Preliminary Consultation MONTGOMERY COUNTY HISTORIC PRESERVATION COMMISSION STAFF REPORT

Address: 10221 Menlo Ave., Silver Spring **Meeting Date:** 6/12/2019

Capitol View Park Historic District

Proposal: New Construction

FRONT AND RIGHT SIDE ELEVATIONS

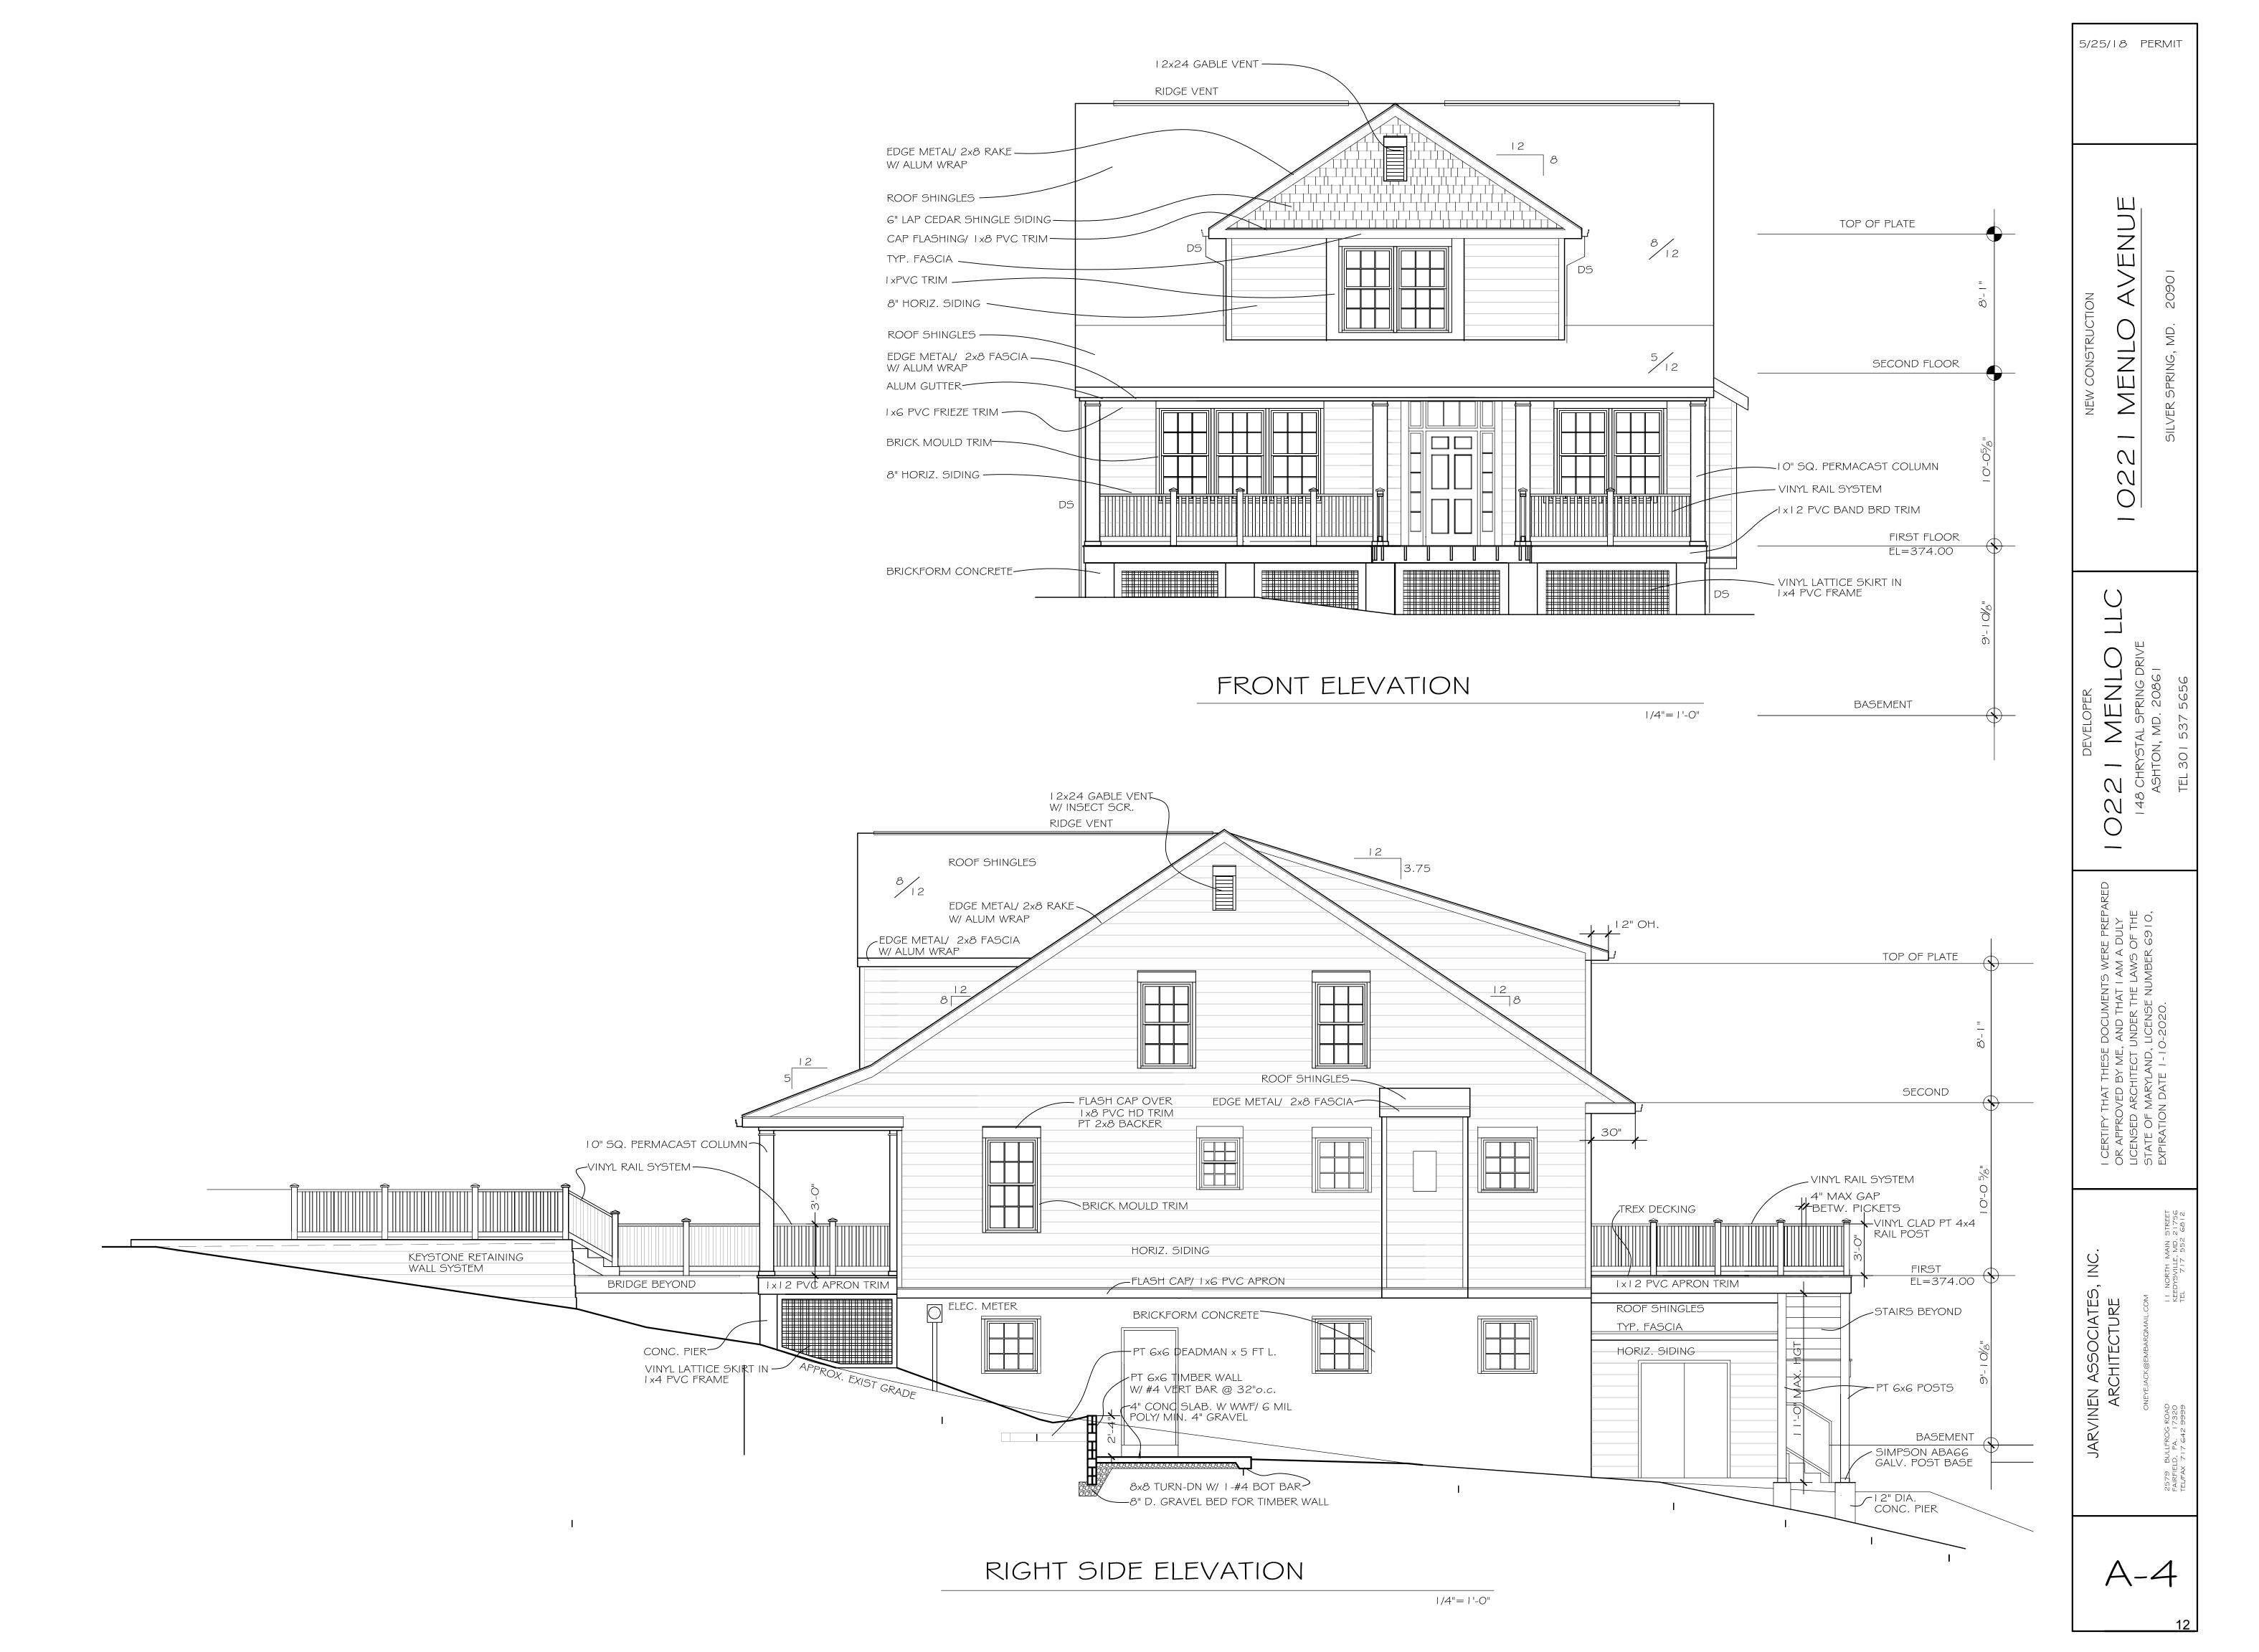
- Siding: The submitted plans only show "8" HORIZ. SIDING." Staff would support either wood clapboard or fiber cement siding in the proposed reveal. The HPC has consistently approved fiber cement siding on building additions and new construction in historic districts. The HAWP application needs to include the material proposed for the exterior cladding.

- Roofing: The submitted plans only indicate roof shingles. Staff finds that either a 3-tab or architectural shingle would be appropriate, however, details of the exact shingle proposed needs to be submitted with the HAWP application.

- Porch Details: The proposed porch will be supported with a 'permcast' fiberglass column with PVC band boards and a "vinyl rail system." Staff has not evaluated specifications for either the columns nor the railing system. Staff has some concerns that both the columns and railing could have an inappropriate appearance that is inconsistent with wood. Staff finds that the PVC trim creates an appearance that is generally inappropriate, even for infill construction within the historic district. Detailed specifications for the proposed railing and columns needs to be submitted with the HAWP application.

- A complete site plan detailing site alterations and maximum limits of disturbance;
- Proposed window and door specifications;
- Building siding details;
- Proposed roof shingles;
- Porch column and railing system details;
- Retaining wall treatment and elevations of the proposed walls from the street and from inside the site;
- Trim details:
- Tree survey;
- Details on proposed stormwater management; and
- Other details identified by the HPC.
